ENGINE - HP TURBINE ROTOR AND STATOR ASSEMBLY - INTRODUCE A NEW STAGE 2 TURBINE BLADE LOCK RETAINER - CATEGORY CODE 4 - MOD.ENG-72-0222

V2500-ENG-72-0222

Location of the Stage 2 Turbine Blade Lock Retainers  
Fig.1

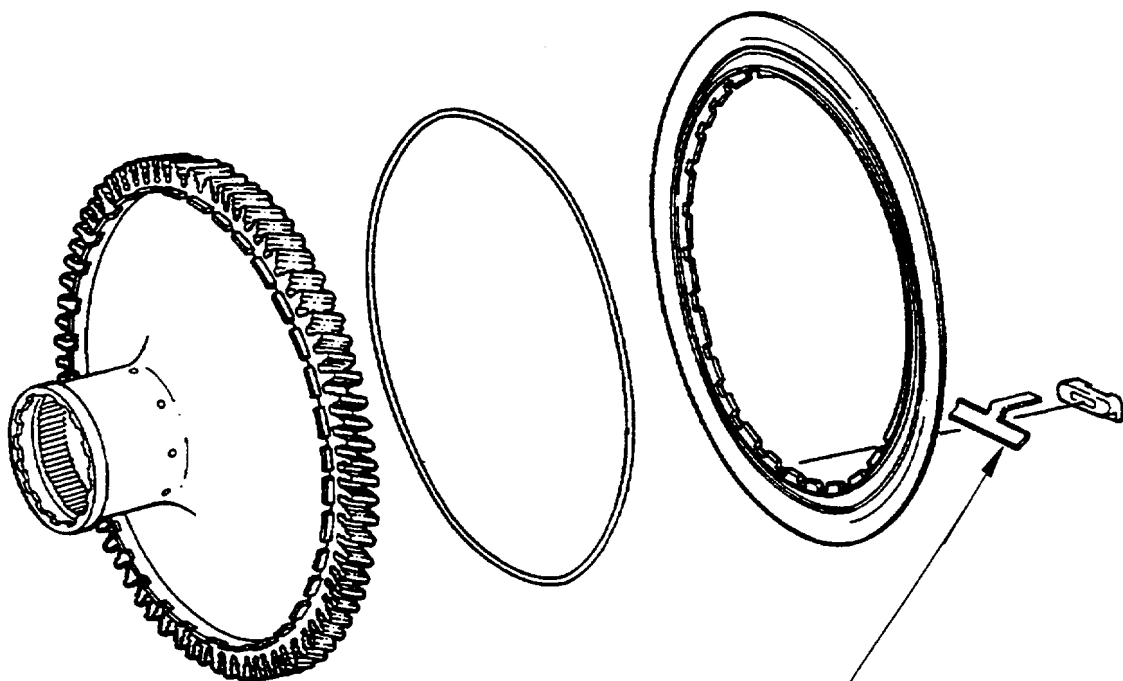
REPLACE THE TURBINE BLADE LOCK  
RETAINER 2A1638 WITH THE TURBINE  
BLADE LOCK RETAINER 2A3158 (2 off)

- (5) Replace the Stage 2 Turbine Blade Lock Retainers 2A1638 with Stage 2 Blade Lock Retainers 2A3158 (2 off) by the procedure specified in Reference (3), Chapter/Section 72-45-30, Assembly.

- (5) Replace the Stage 2 Turbine Blade Lock Retainers 2A1638 with Stage 2 Blade Lock Retainers 2A3158 (2 off) by the procedure specified in Reference (4), Chapter/Section 72-45-30, Assembly.

Family Tree - Stage 2 HPT Blade Lock Retainers (V2500-A1) Ref. Catalog Sequence No 72-45-33. Fig. 01 Item 040  
Fig.2

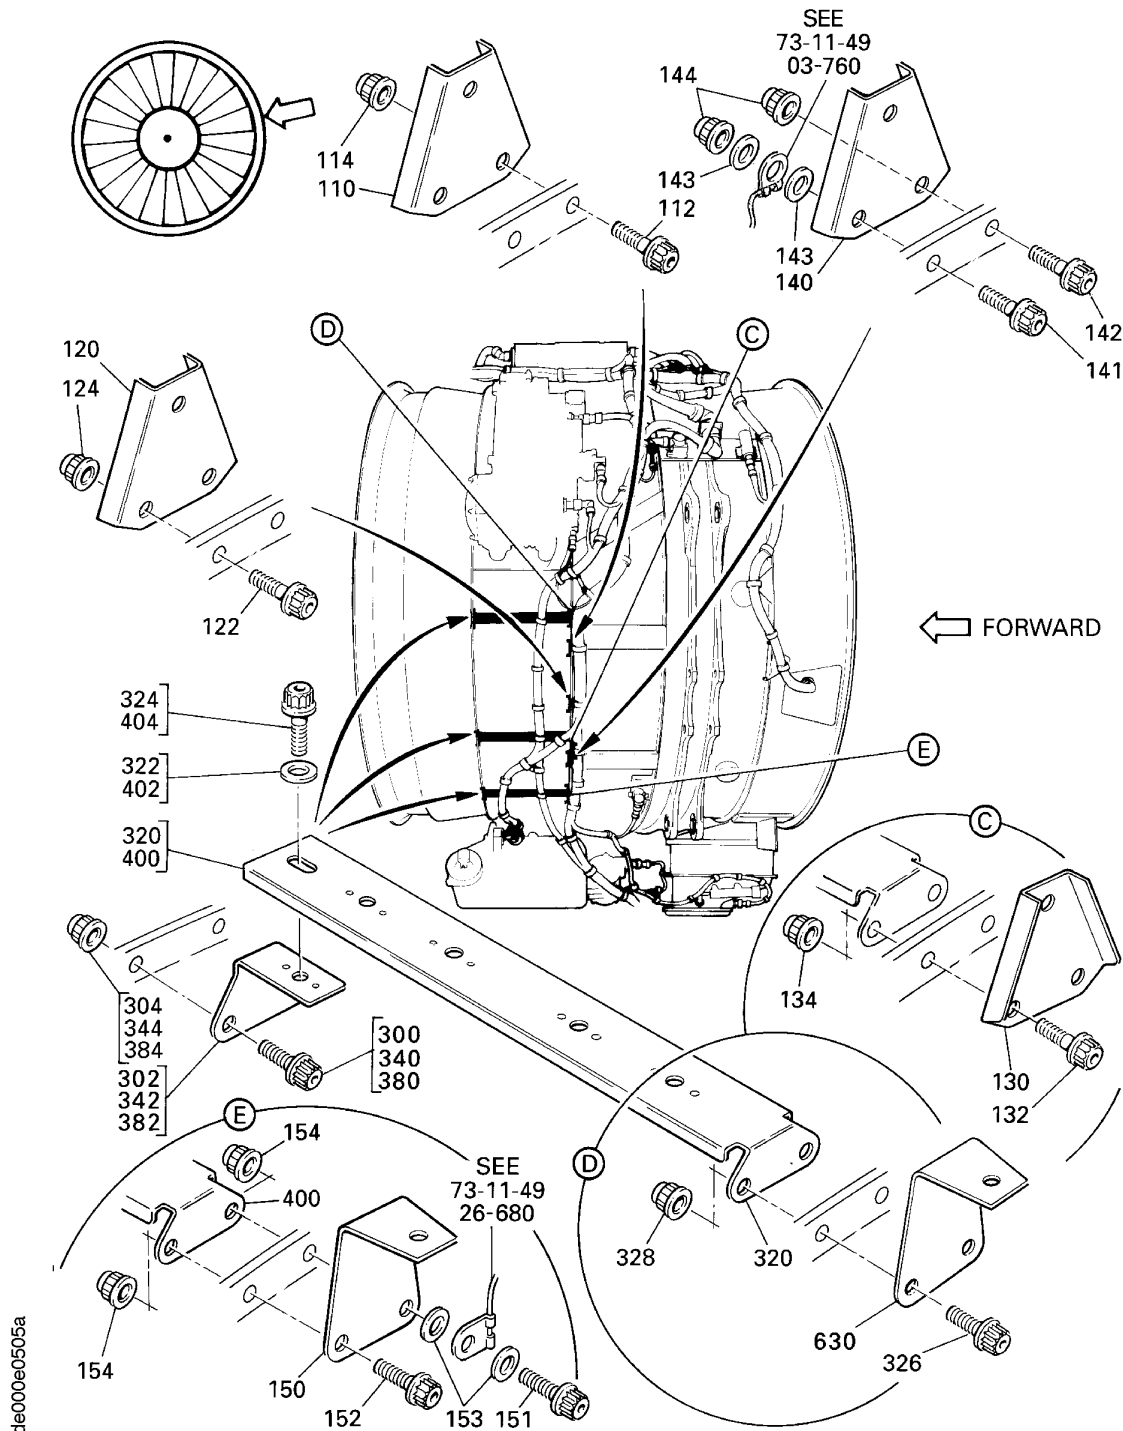
- (S1)Old and New Parts are freely and fully interchangeable  
(A) The new part will be available approximately 12/95.  
(B) The old part will no longer be available.
